AGENDA

La Vergne Planning Commission
September 30, 2025 at 6:00 PM

Item #: 4. Site Plan – Restaurant and Retail Building at 192 & 198 Old Nashville Highway – Existing and Proposed Buildings of 15,521 Square Feet on 1.35 Acres. Requested by Huddleston Steele. Property located at 192 & 198 Old Nashville Highway (Tax Map 15M, Group E, Parcels 4 & 5). C-2 (Highway Service) Zoning District. Property owned by Better Home, LLC.

PROJECT NO. 1574-01	
SEPTEMBER DATE: 2025	DRAWN BY: HLP
	CHECKED BY: RWM
SCALE: 1"=30'	APPROVED BY: RWM
SHEET NO. C2.01

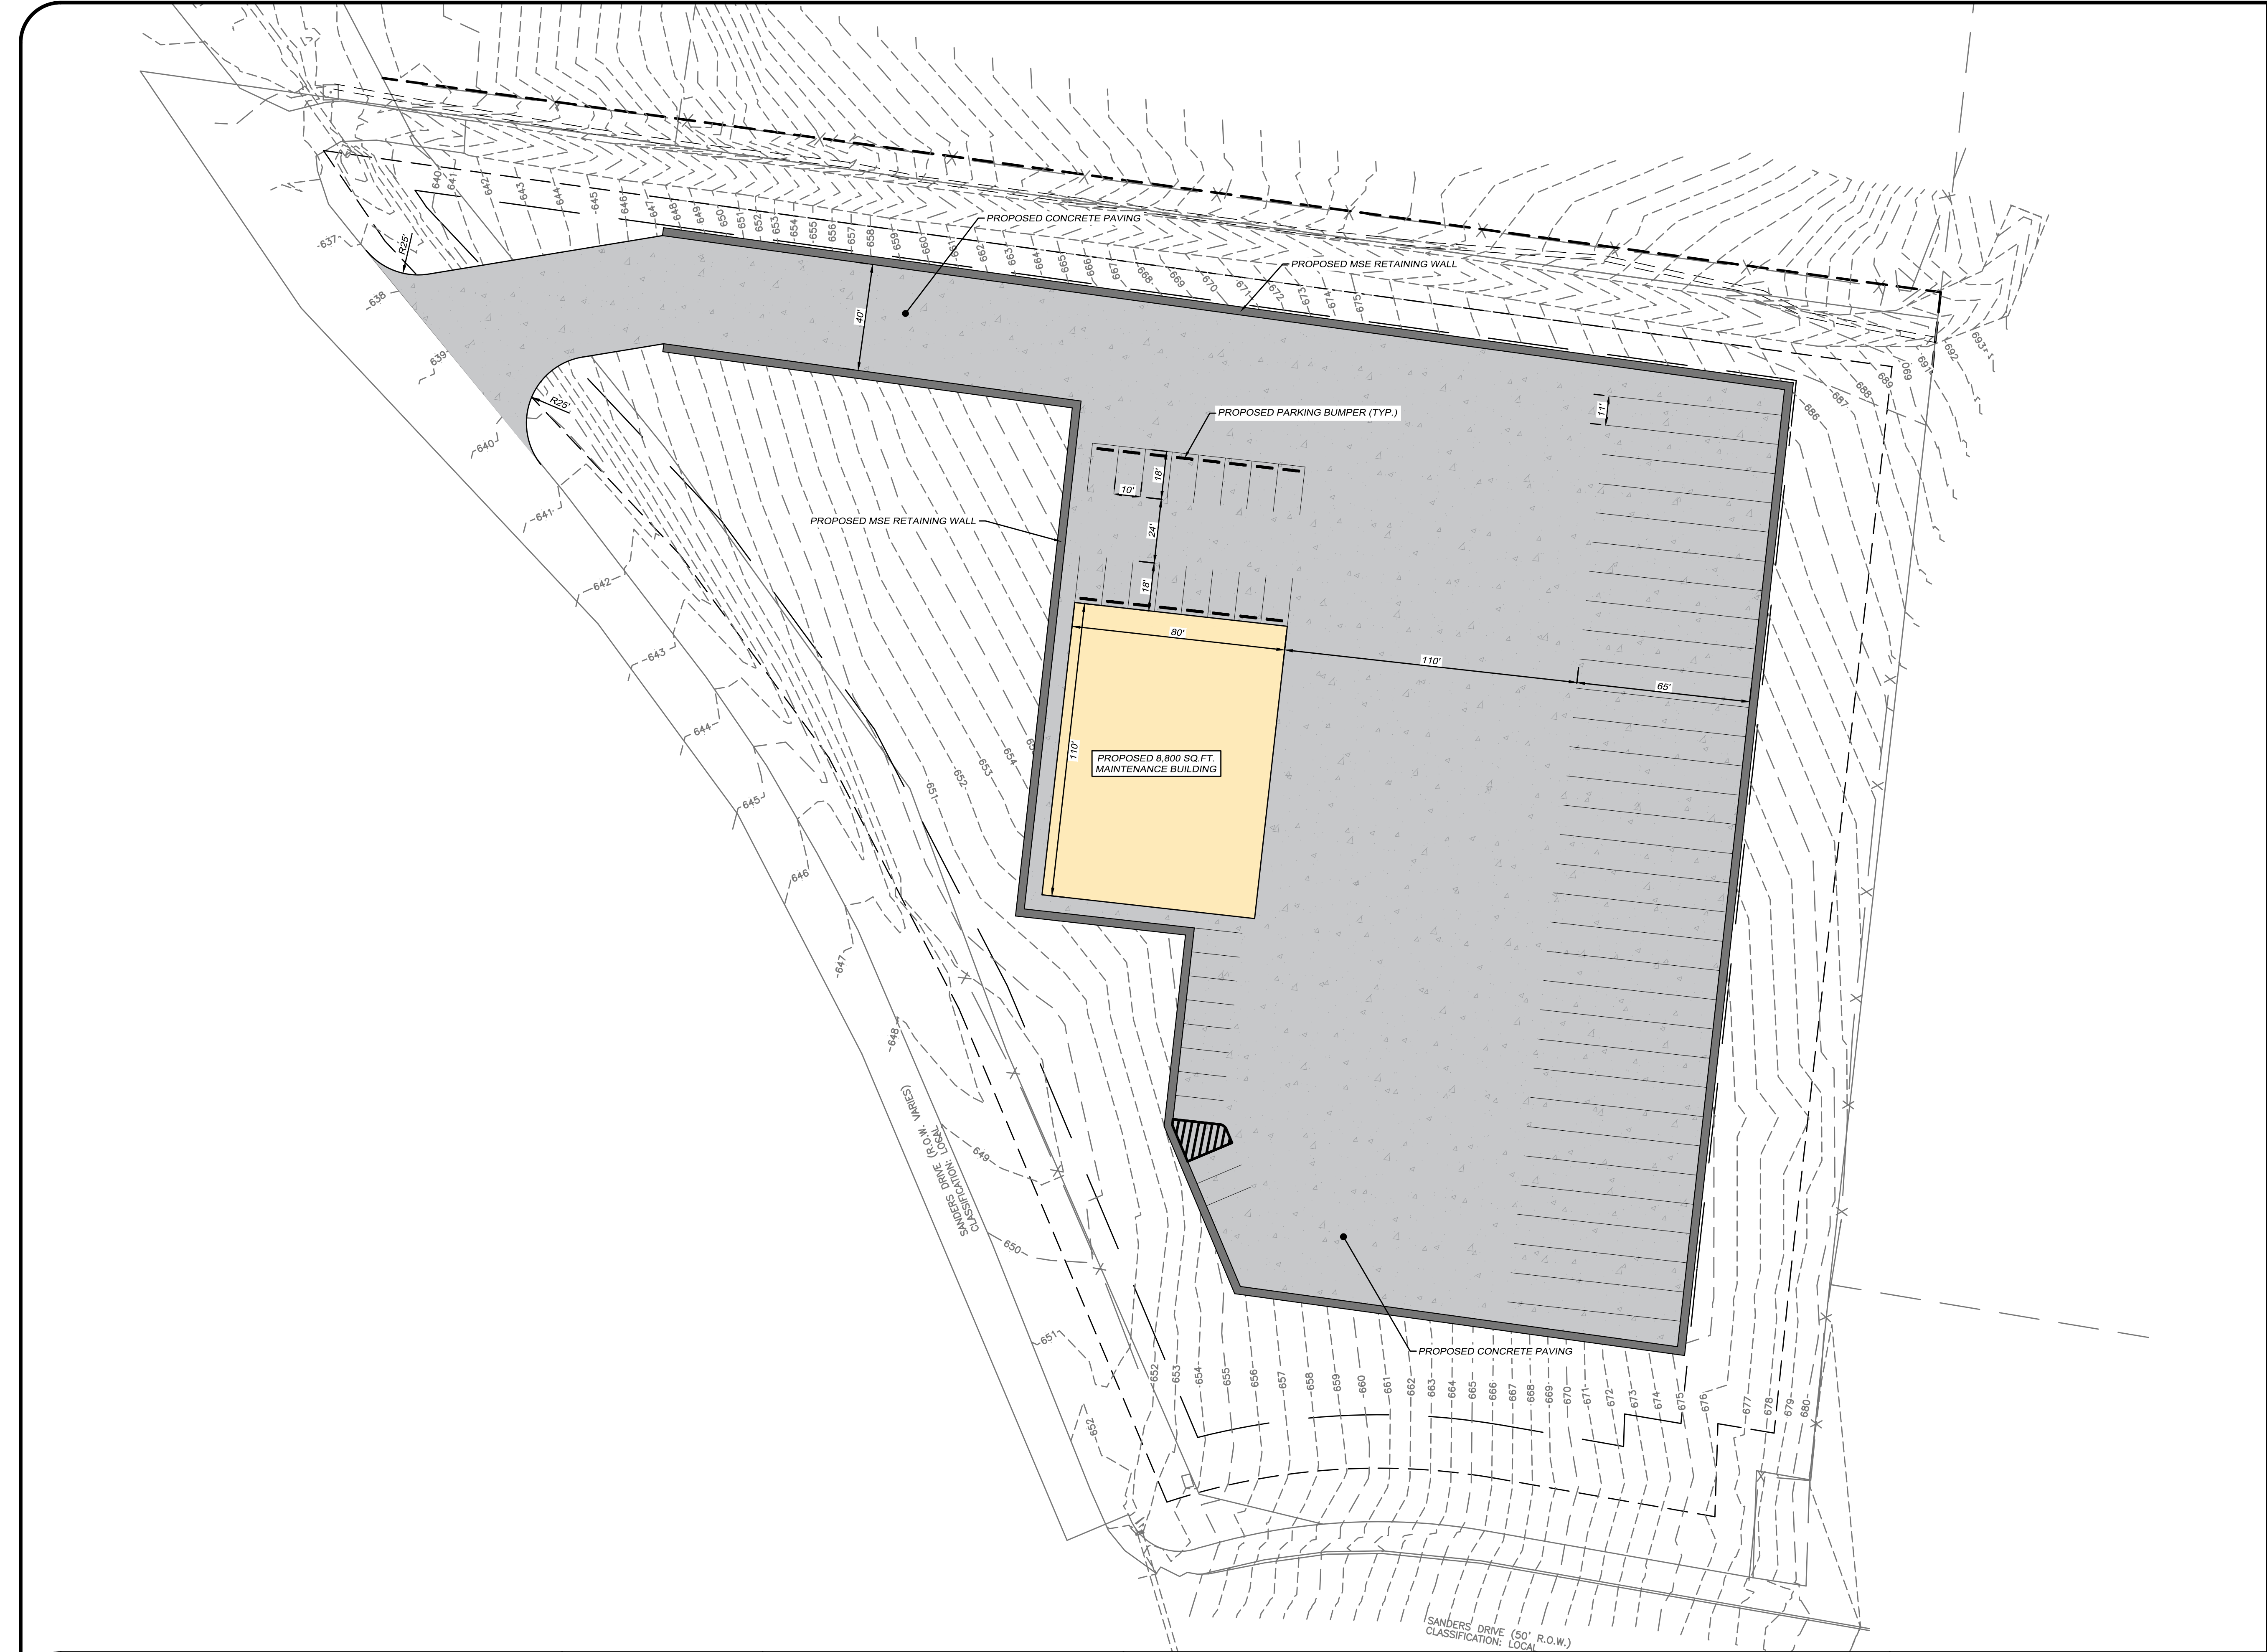
8. (Sheet C2.01) Show distances from two perpendicular boundaries to the building so that the building can be located in the field.
9. (Sheet C2.01) Show lane striping for entry drive.

13. (Sheet C2.01) Provide concrete pavement section for drive and parking areas
14. (Sheet C1.01) Add DB 593, PG 125 to the access easement
15. While a full traffic study will not be required, please provide traffic generation estimates for the proposed use.

16. (Sheet C2.01) Provide ADA accessible spaces as required
17. (Sheet C2.01) Question: Is a monument sign proposed at the road? If yes, please show location and size.

32. (Sheet C2.01) Show far side edge of pavement for Mason Road and show edge of [pavement for Tech Park Drive
33. (Sheet C4.01) Show size, material, and invert elevations of existing pipe under the access drive along the North boundary

46. Provide a Site Profile from the centerline of Mason Road and following the centerline of the driveway to the nearest point of the building.
47. (Sheet C2.01) Show five-foot wide sidewalk along all public road frontages

48. (Sheet C2.01) Show dumpster pad or provide a narrative explaining how waste will be handled without a dumpster.
49. The City specifications have required General Notes. These must be included. They can be found at: <https://www.lavergnetn.gov/DocumentCenter/View/4671/Permitting-and-Construction-General-Information-and-Requirements>

SHEET NO. C4.01

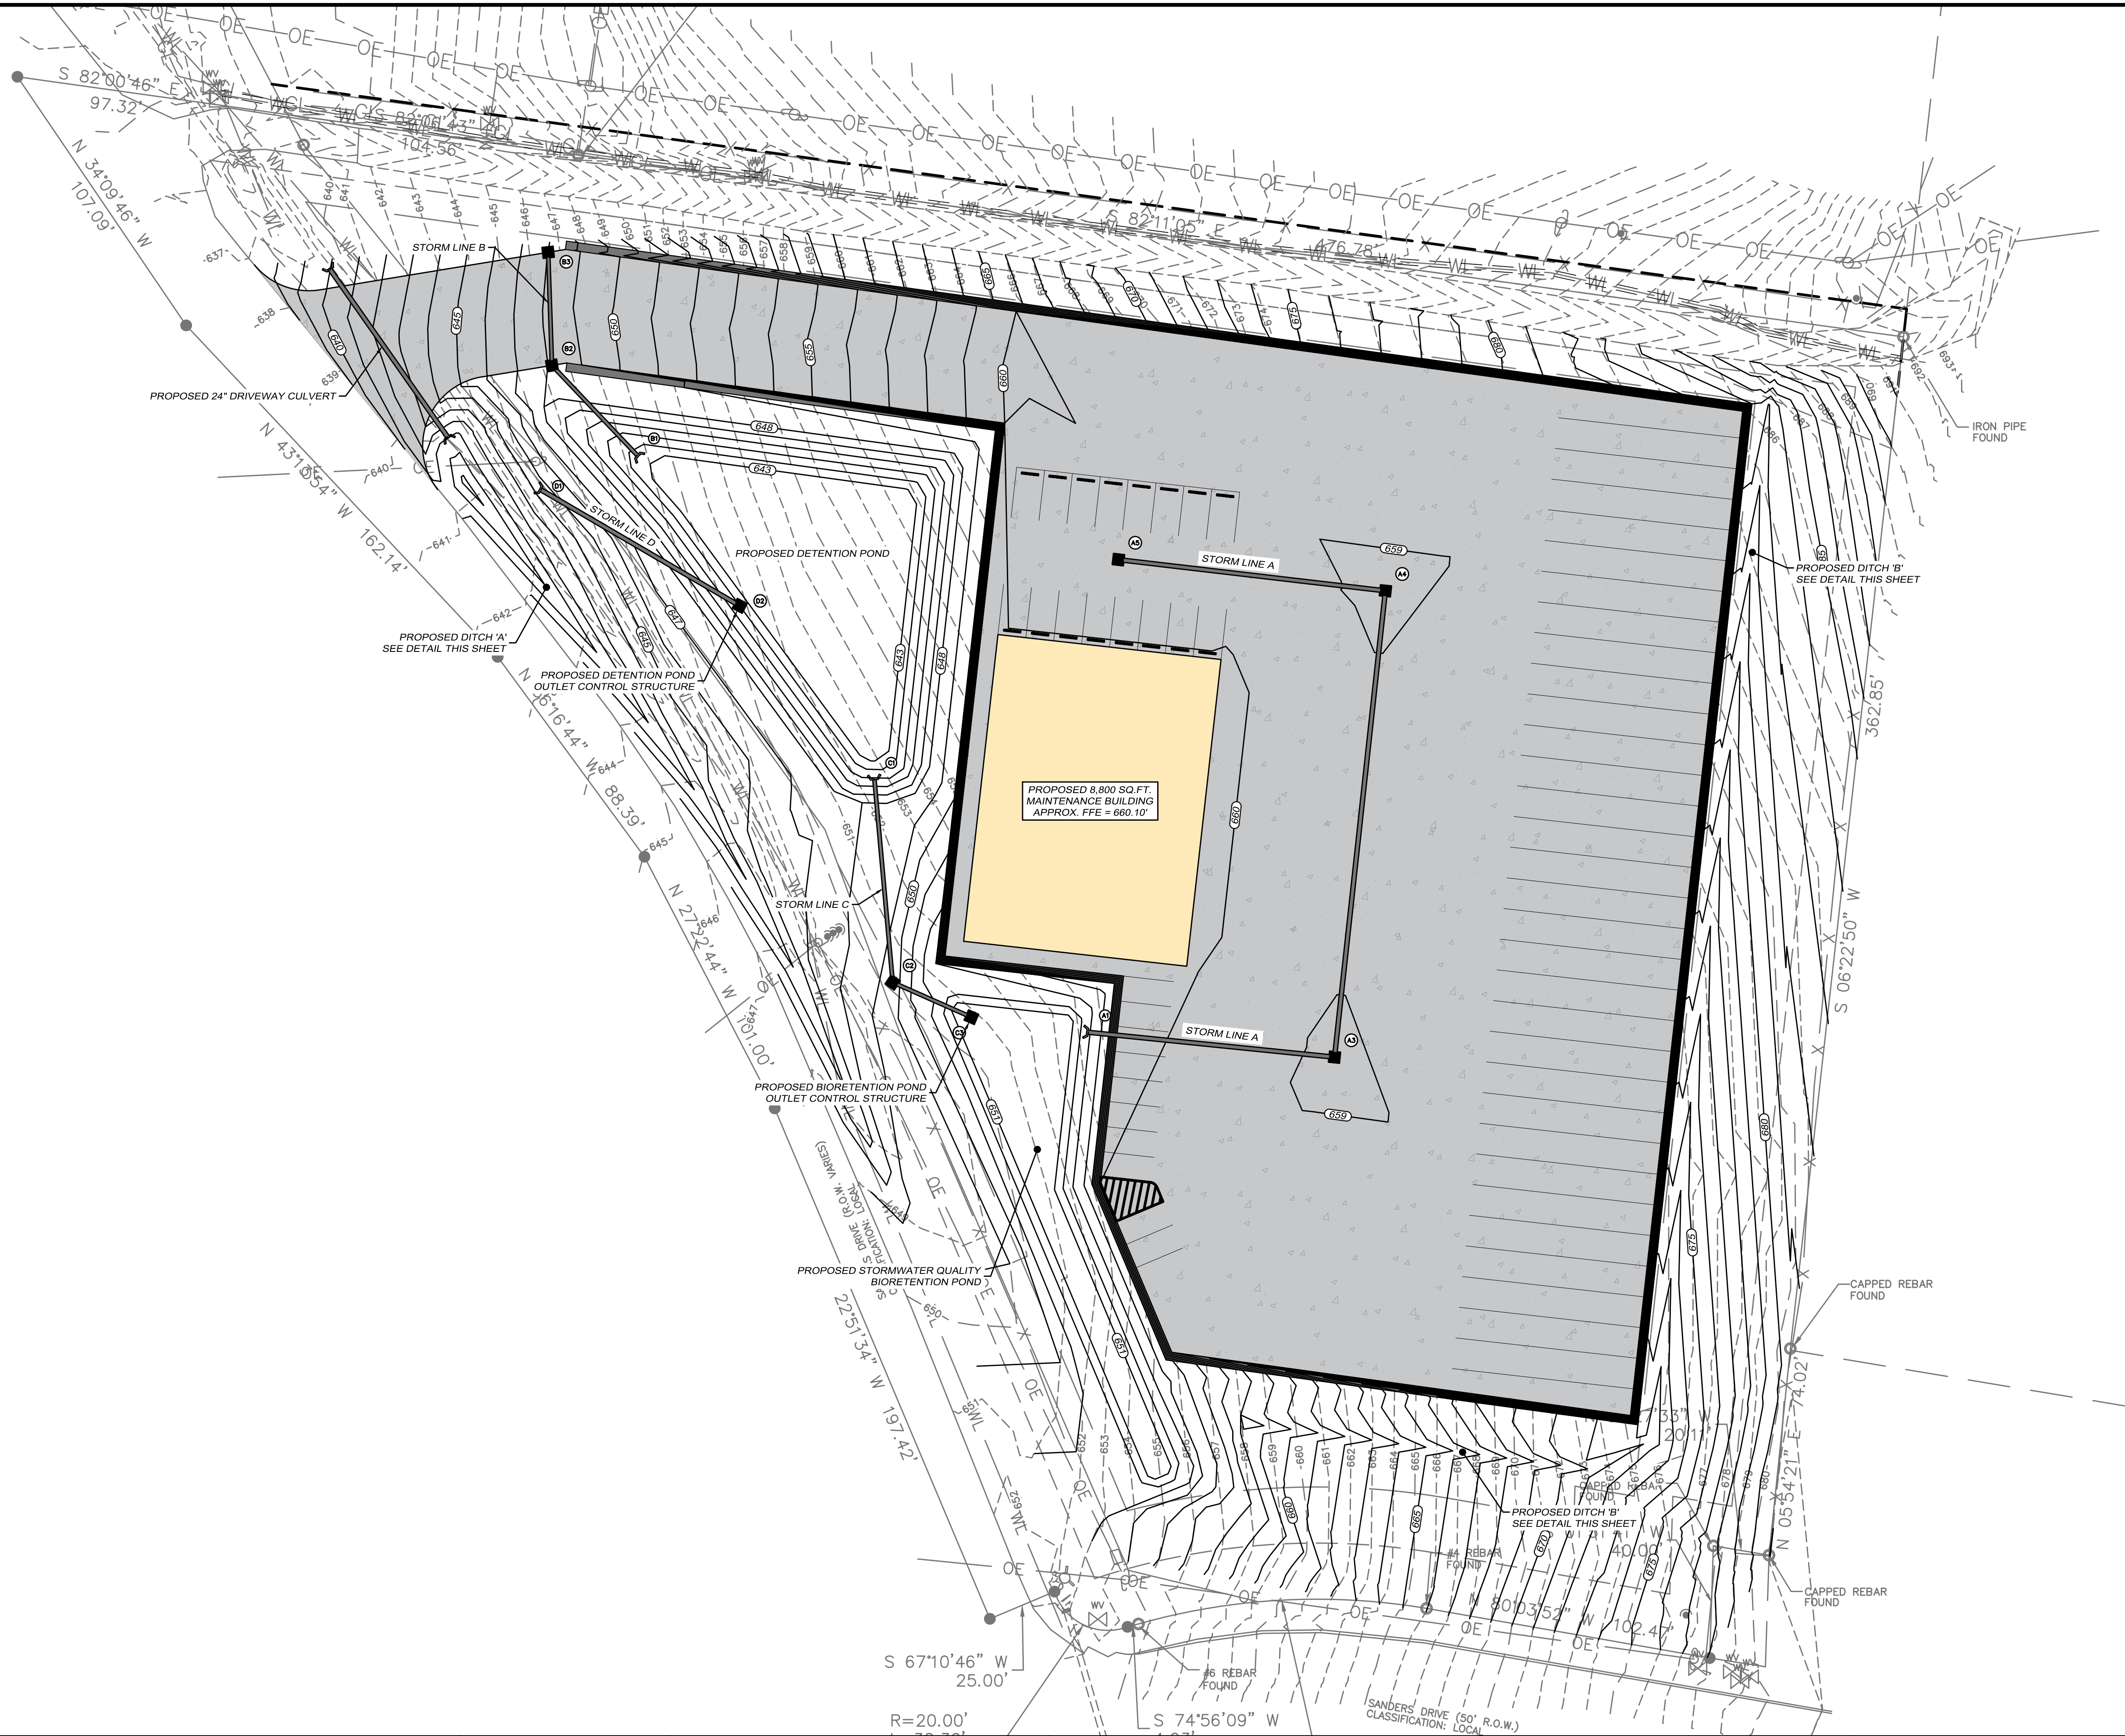
18. (Sheet C4.01) Ditch B south of parking area flows along a nearly 8% in slope. Maximum flow velocity for Curlex blanket is 7%. Provide a more robust ground cover in that section of Ditch B.

19. Provide all calculations required by the La Vergne Stormwater Management Ordinance including stormwater quality and stormwater quantity.
20. (Sheet C4.01) In the western end of Ditch B where it outflows into the bioretention pond, provide riprap or other similar protection where the ditch slope flattens out into the pond.

21. (Sheet C4.01) Provide erosion protection from the outfall of Storm Line D down to the flowline of Ditch A.
22. (Sheet C6.03) Provide a note that all EPSC controls shown on this sheet are permanent.

23. (Sheet C4.01) Provide a swale along the top of the retaining wall along the north edge of the parking area and provide a detail for the swale.
24. (Sheet C4.01) Provide details showing how the outlet control structures will be constructed which match the calculations.

25. (Sheet C4.01) Provide hydraulic calculations for pipes as required by Stormwater Management Ordinance
26. Provide construction details for catch basins, headwalls, pipe trenching, etc.

27. (Sheet C4.01) Show how bypass Q is going to be avoided at catch basins B2 and B3.
28. (Sheet C4.01) For all pipes, catch basins, and headwalls, show pipe size, material, invert elevations, and top of casting elevations.
